## PLANNING REPORT

### PLANNING AND ZONING COMMISSION

OCTOBER 8, 2009

**2. Kumon Learning Center** **4056 West Dublin-Granville Road**  
**09-067Z/PDP** **Rezoning/Preliminary Development Plan**

# PROPOSED ARCHITECTURE

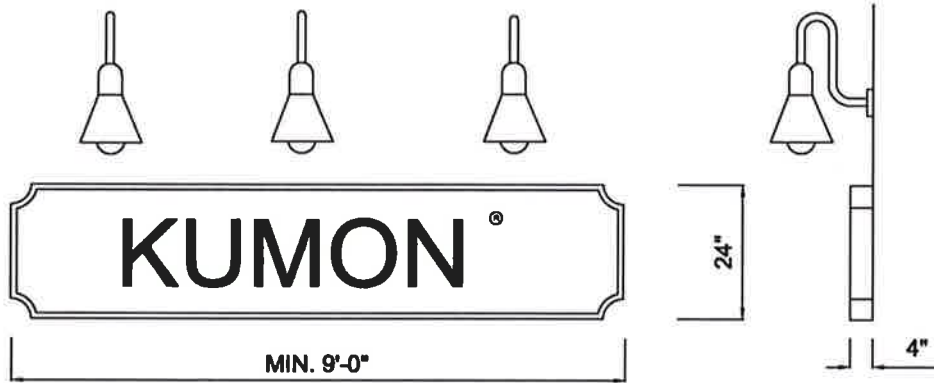
described in the proposed text, the architectural theme is generally consistent with that which was approved for Shamrock Crossing. However, the proposed architectural drawings do not translate several significant design details typical of the approved Shamrock Crossing development. These details are essential to creating a consistent character, and the following comments will need to be addressed and implemented prior to final development plan approval:

- The individual tenant spaces will need to be more effectively differentiated and articulated. The same basic window, door, and awning details are repeated on all six tenant façades (front and back) as well as on the side elevations. More attention should be given to using a variety of storefront designs, windows, and awning types, as exhibited in the architectural renderings for the nearby Shamrock Crossing development.
- The locations of exterior building materials and transitions between building materials should be given further consideration in order to more accurately reflect the character of Shamrock Crossing.

The plans currently depict 22.5-square-foot wall signs on the north elevation facing the parking lot. It is Planning's opinion that the signs oriented toward the parking lot should be at a smaller, more pedestrian-oriented scale. To this end, prior to scheduling a hearing at City Council, the text should be modified to stipulate that these wall signs oriented toward the parking lot may be a maximum of six square feet. The applicant may choose wall signs, directory signs, or blade signs (Condition #7).

- 8) That the applicant continue to work with Planning to implement and refine the design details discussed in this report prior to final development plan approval.
